Technical Service Bulletin

Topic	93 e-tron update OBC software when replacing HV wiring harness for charging socket - NTC to PT1000 charging socket
Market area	United States 444 Volkswagen of America, Inc. (6444)
Brand	Audi
Transaction No.	2070110/5
Level	EH
Status	Released for publishing
Release date	Apr 23, 2025

Figure 1. High-voltage wiring harness for charging socket.

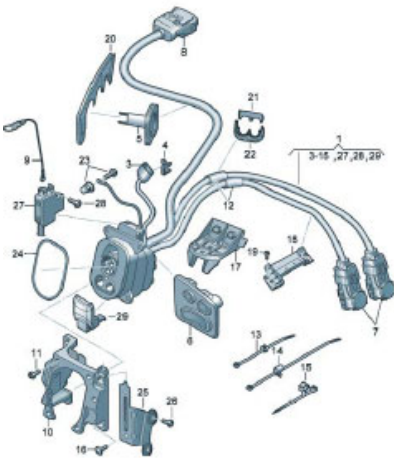
The High Voltage Wiring Harness for the charging socket UX4 or UX5 is replaced as part of any repair work (Figure 1).

The charging socket was modified in production.

From Q2 2020, only the new-generation high-voltage wiring harness for the charging socket is fitted in production vehicles.

It is essential to check the part number of the removed original high-voltage wiring harness and of the new replacement high-voltage wiring harness.

If the high-voltage wiring harness for the charging socket is replaced as listed in Table 1.2, an SVM code will need to be performed, *and a replacement test plan performed.*
